GE Nuclear Energy

Project 717

MFN 03-101
September 19, 2003

Subject: **Response to Request for Additional Information (RAI) numbers (54, 79, 100, 101, 109, 259, 282, 309, 311, 333, and 383) for ESBWR Pre-application Review.**

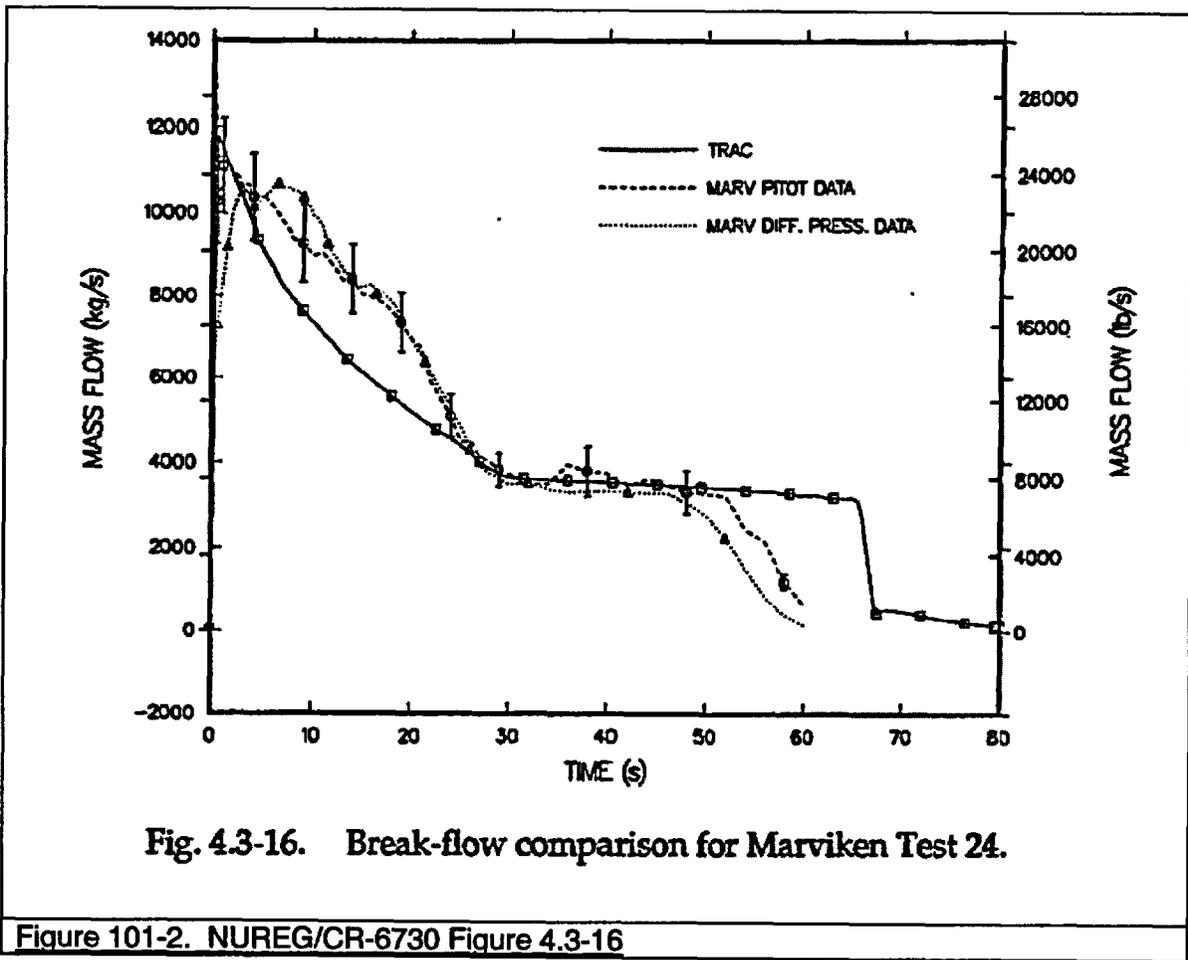
Q100. Section 3.4.1.2 (p. 3-48) - What was the uncertainty of the pressure measurement?

R100 The uncertainty in the pressure measurement for the Marviken critical flow tests is 90 kPa [Reference 100.1].

Reference 100.1: TRACC-M/F77, Version 5.5 Developmental Assessment Manual, NUREG/CR-6730, Vol.1, page 4.3-2, July 2001.

Figure 333-1 Theoretical Sonic Velocity for HEM of Steam and Water

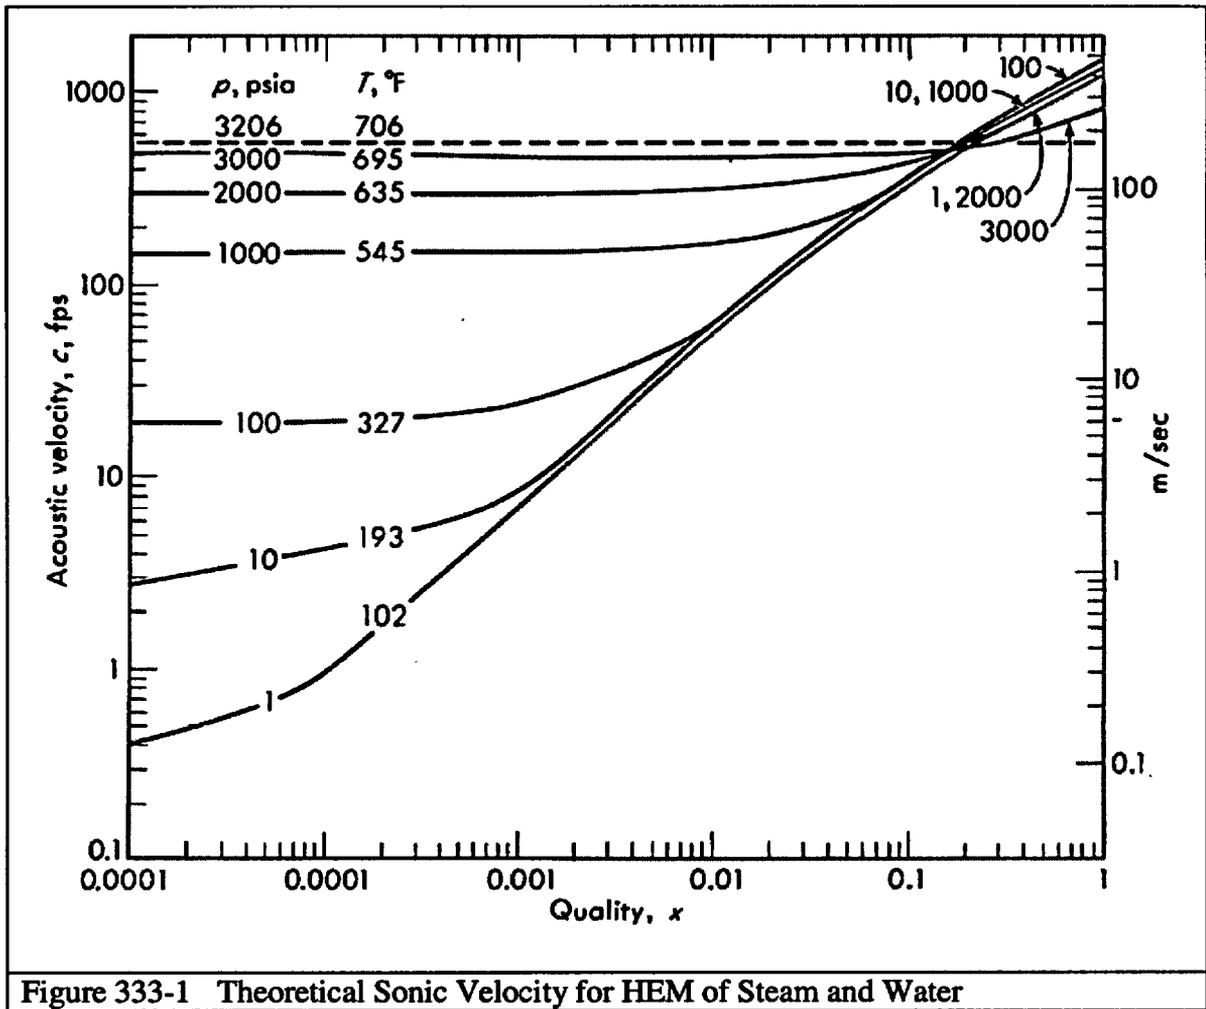
Q333. In order to verify the TRACG critical flow model, we have developed and run a simple test problem. It consists of two break components and a pipe component. Two break components define the pressure boundary conditions (73 bar upstream and atmospheric pressure downstream). A pipe with an orifice at the center was initially set to 73 bar through out its entire length. Then, the downstream break is depressurized to atmospheric pressure. The TRACG code predicts choke condition at the orifice. However, the calculated fluid velocity at the choke point is only about 60 meters per second. Usually, the sound speed is expected to have be on the order of 100 - 300 meters per second. Therefore, the calculated choke flow velocity appears to be lower than the sound speed. Please provide a separate effect test benchmark TRACG deck to assist the staff's further review.

R333. The sonic velocity varies as a function of stagnation pressure and quality at the choke plane. Both have a strong effect on the velocity of sound in homogenous, equilibrium mixtures (HEM) of steam and water. These relationships are shown in Figure 6.11 on page 146 of Graham Wallis's book One-dimensional Two-phase Flow (McGraw Hill, New York, 1969). Wallis attributes the figure to H. B. Karplus (1958). For convenience, it is reproduced here as Figure 333-1. The figure shows that one should expect that for a pressure of 73 bar (1059 psia) that the HEM sonic velocity is approximately 50 m/s for qualities of 0.05 or lower. At the choke plane where the pressure is lower, the sonic velocity is even lower.

The sonic velocity is discontinuous at qualities of 0.0 and 1.0 corresponding to the transitions between single-phase and two-phase flow. This discontinuity in sonic velocity is due to the discontinuity in the specific heat at constant volume (C_v) that occurs at these points. The fact that this will lead to a discontinuity in the sonic velocity is evident from equations (D-10), (D-17) and (D-18) in Appendix D of NEDE-32176P (Rev. 2). This discontinuity is the reason that the sonic velocity can be as much as an order of magnitude lower for low-quality steam-water mixtures than it is for single-phase saturated liquid at the same pressure.

Appendix E of NEDE-32176P (Rev. 2) contains the derivation of the HEM sonic velocity that is used in TRACG. The crux of the problem is to define the compressibility at constant entropy. The simplified form with no noncondensable gas is presented in Eq. (E-40). Free and Spore have obtained the same result (see References 6.3-1 and 6.3-2 cited in NEDE-32176P, Rev. 2). The conclusion is that the fluid velocity of approximately 60 m/s calculated by TRACG at the choke point is a reasonable value.
